Access Compliance Report

Public Rights-of-Way

(Curb Ramps)

Intersection ID: 27906	Main Street: BALLANTYNE COUNTRY CLUB DR	Cross Street: HARRISON'S CROSSING AV	Location: SW
ADA ID: FD896599D6E3	Ramp Type: BlendTrans2	Initial Pass/Fail: Fail	Overall Compliance: No
Codes/Mitigation Info/Possible Solution		Field Measurements/Component Compliance	
Severity Score: 12.5

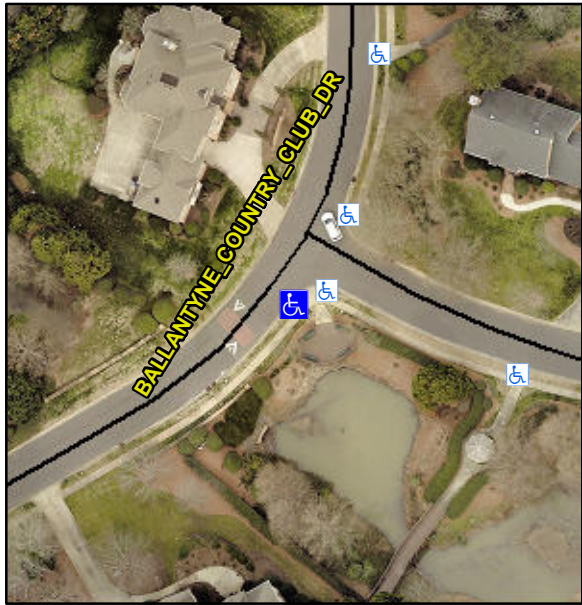
Not Found, R304.5.3

Compliance	Description	Data	Compliance	Description	Data
N/A	Ramp Length (in)	96.0	Yes	BlendTrans Slope (%)	2.8
Yes	Ramp Width (in)	48.0	No	BlendTrans XSlope (%)	6.2
N/A	Flare Type LT	N/A	N/A	Flare Type RT	N/A
N/A	Flare Slope LT (%)	N/A	N/A	Flare Slope RT (%)	N/A
N/A	Flare Traversable LT?	N/A	N/A	Flare Traversable RT?	N/A
N/A	Landing Length (in)	N/A	N/A	DWS Provided?	N/A
N/A	Landing Width (in)	N/A	N/A	DWS Contrast?	N/A
N/A	Landing Slope (%)	N/A	N/A	DWS Length (in)	N/A
N/A	Landing X Slope (%)	N/A	N/A	DWS Full Width?	N/A
N/A	Landing Curb? (Y/N)	N/A	N/A	DWS Offset (in)	N/A
N/A	Shared Landing?	N/A			
N/A	Gutter Ponding?	N/A	N/A	Gutter Slope (%)	N/A
N/A	Gutter Lip Ht (in)	N/A	N/A	Gutter X Slope (%)	N/A
N/A	Painted X Walk1?	No	N/A	Painted X Walk2?	N/A
	X Walk 1 Direction	To NW		X Walk 2 Direction	N/A
	X Walk 1 Width (in)	N/A		X Walk 2 Width (in)	N/A
	X Walk 1 Slope (%)	1.9		X Walk 2 Slope (%)	N/A
	X Walk 1 X Slope (%)	3.0		X Walk 2 X Slope (%)	N/A

N/A	Ramp inside XWalk1?	N/A	N/A	Ramp inside XWalk2?	N/A
	Road Slope (%)	3.0		Clear Space?	N/A
	Road X Slope (%)	1.9	N/A	Clear Space to XWalk (in)	N/A
N/A	Any Obstructions?	N/A	N/A	Storm Grate/Utility Hazard?	N/A
	Obstruction Type			Storm Grate/Utility Type	
		N/A			N/A
			Yes	Surface Condition? (G/P)	Good
			No	Curb Slope (%)	15.0

Remove & Replace Curb Ramp With Two New Directional Ramps or Equivalent.
